Note: Two sets of workshops were held for this petition, May - June 2006 and November - December 2007

WORKSHOP Comments

Comment Letters 06/2006

**Cadmium Criteria and Hardness
Acute (CMC) concentrations**

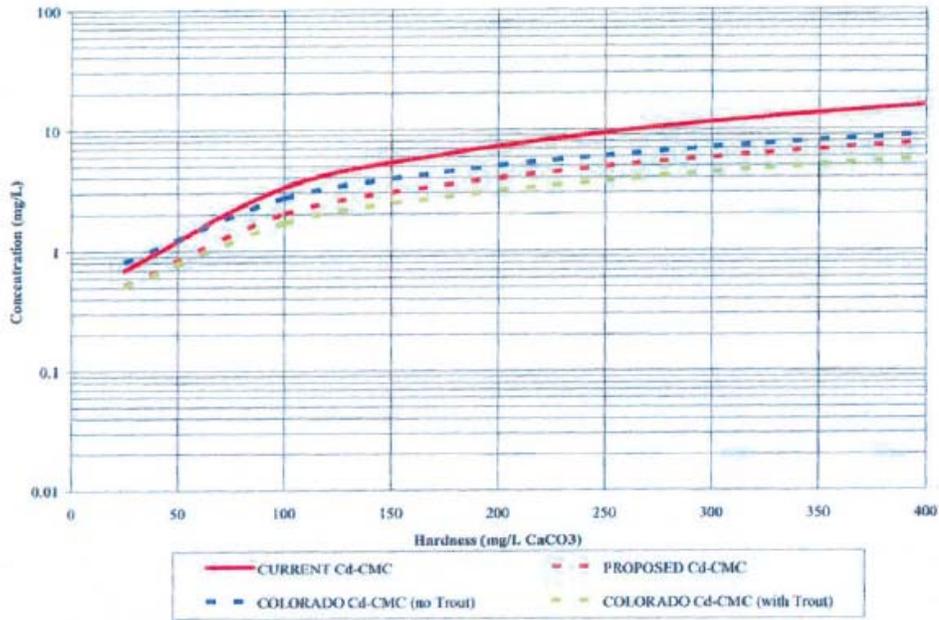
A comparison of the current Nevada acute and chronic equations with the proposed Nevada equations and the current Colorado equations is provided in the attached plots.

- 1) Based on the information provided to Colorado DPHE by the regulated community in Colorado and the decision by Colorado to adopt these equations, NDEP should review and consider the data and adopt the revised cadmium acute and chronic hardness-based equations. The BWQP should adopt the general acute equation. The trout based equation could be considered for surface waters where trout have been identified as an aquatic life species of concern.
- 2) NDEP also should add language to NAC 445A.144, as a footnote, that provides for site-specific and species-specific application of the acute and chronic cadmium equations where appropriate and adequately supported. An example footnote could read:
